1st Further Information

Proposed Temporary Private Vehicle Park (Heavy Goods Vehicles) and Open Storage of Construction Materials and Machinery with Ancillary Facilities and Associated Filling of Land for a Period of 3 Years in "Agriculture" Zone and area shown as 'Road', Lot 1095 in D.D. 82, Ta Kwu Ling, New Territories

(S.16 Planning Application No. A/NE-TKL/856)

(i) The applicant would like to submit a response-to-comments table for the consideration of government bureaux/departments:

DWG. TITLE
LANDSCAPE PROPOSAL

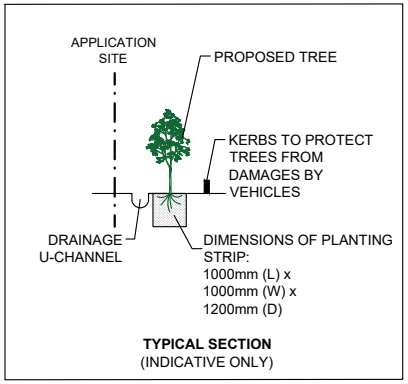
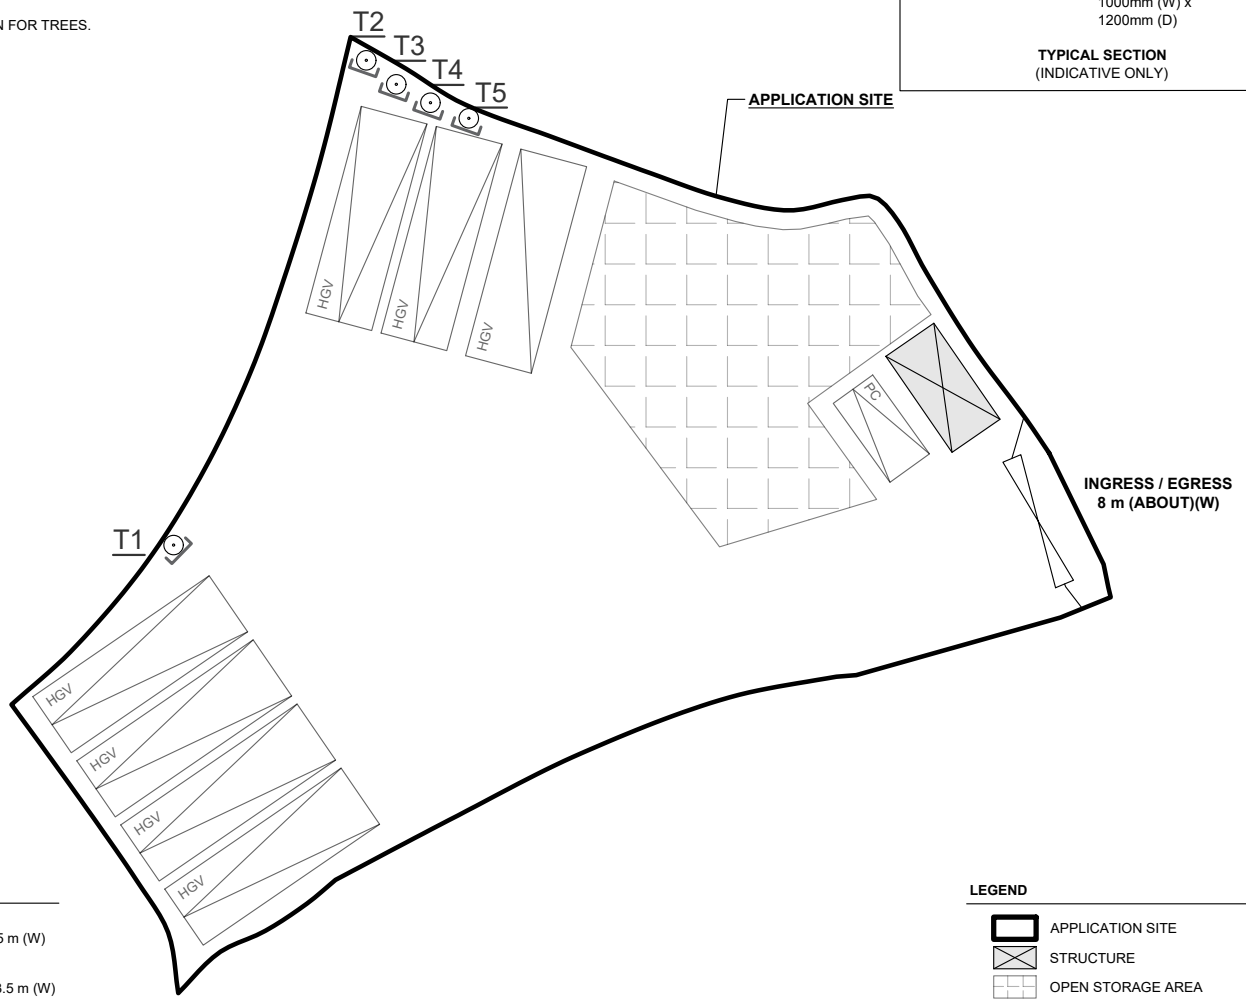
(1)	As noted on Plan 6, land filling of the whole site is proposed which may lead to tree felling. This contradicts the Application Form which states that no tree felling will be involved. Please review and clarify.	According to a tree survey conducted by the applicant, 5 nos. of trees were identified within the site boundary. No OVT or protected species has been identified. Due to land filling in the Site, all identified trees are proposed to be felled. A landscape proposal is provided by the applicant (**Appendix II**) where 5 new trees (i.e. Bauhinia Blakeana) (T1 to T5) are proposed to be planted at the southeastern portion of the Site as a landscape buffer. The proposed 5 new trees will be planted at least 1.2m soil depth for better tree health. The new proposed trees are for mitigating any potential visual and landscape impact (if any) towards nearby sensitive receivers. The new trees planted within the Site will be maintained by the applicant in good condition during the planning approval period.

SWEPT PATH ANALYSIS (HGV)

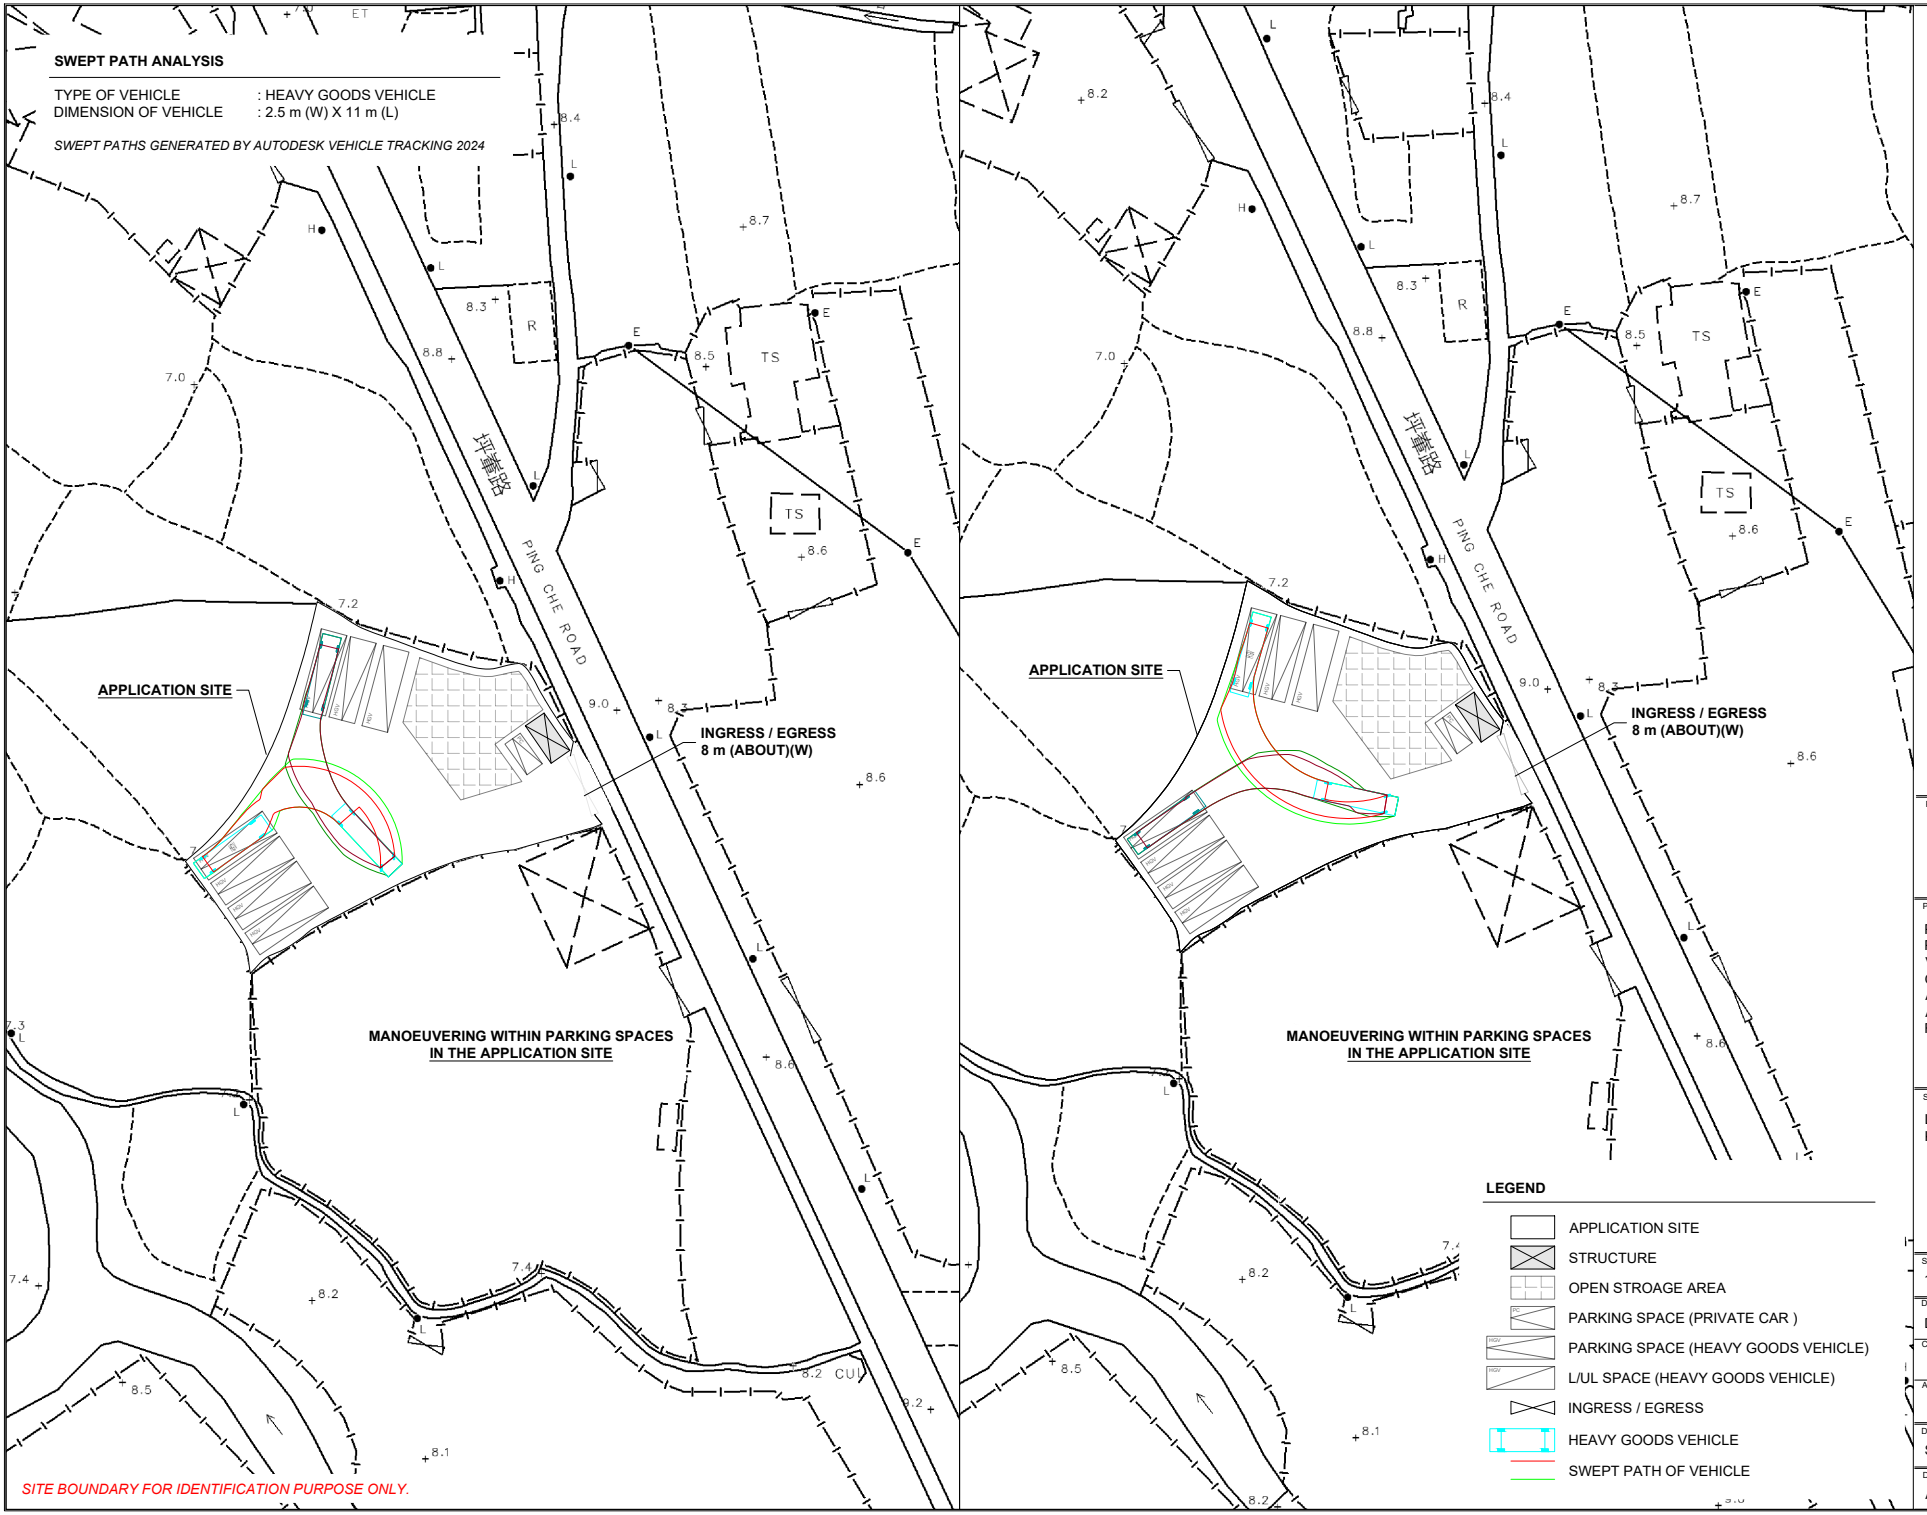
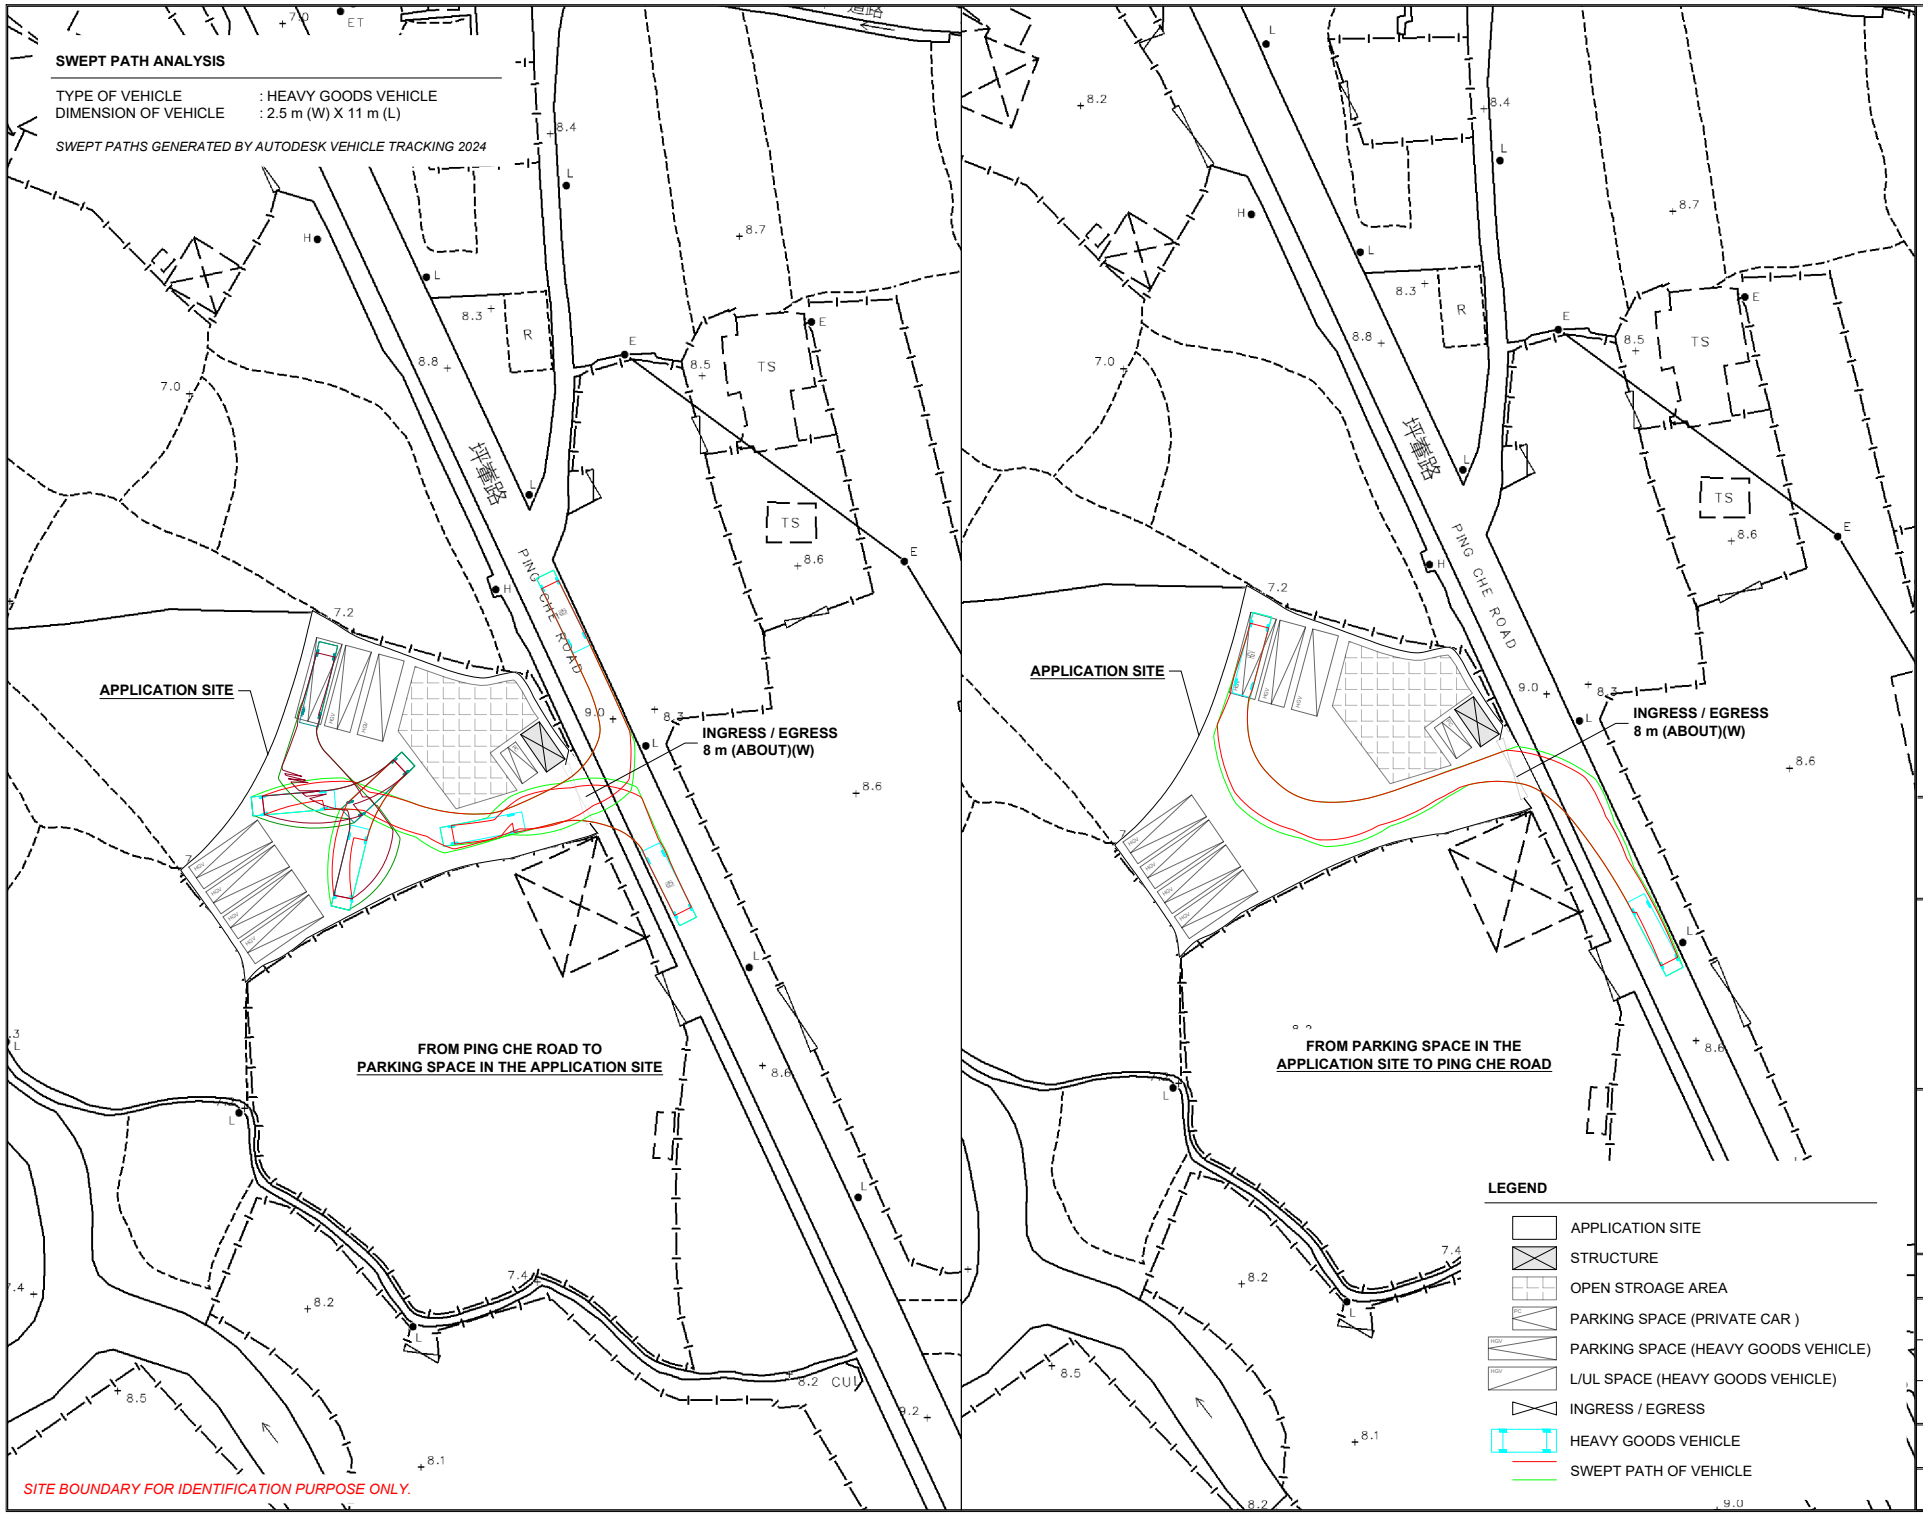
Comments of the Commissioner for Transport (C for T) (Contact Person: Mr. Yvette LI, Tel.: 2835 2390)		
(1)	The applicant shall demonstrate the manoeuvering of the heavy goods vehicles manoeuvering within the shaded parking and loading/unloading spaces in Appendix I and entering/leaving Ping Che	Noted. Please find swept path analyses at **Appendix III**. The swept path analyses have demonstrated that sufficient spaces are provided for heavy

Road to/from the application site without encroaching opposite lane;	goods vehicles to manoeuver within different parking and loading/unloading spaces within the Site and entering/leaving the Site. The applicant will only allow all vehicles other than private cars to turn right when leaving the Site. No left turns are allowed for vehicles other than private cars. This is to minimise potential impacts made to the surroundings. Also, staff will also be deployed by the applicant to direct vehicles entering/exiting the Site to ensure vehicles could safely leaving/rejoining traffic to and from Ping Che Road.
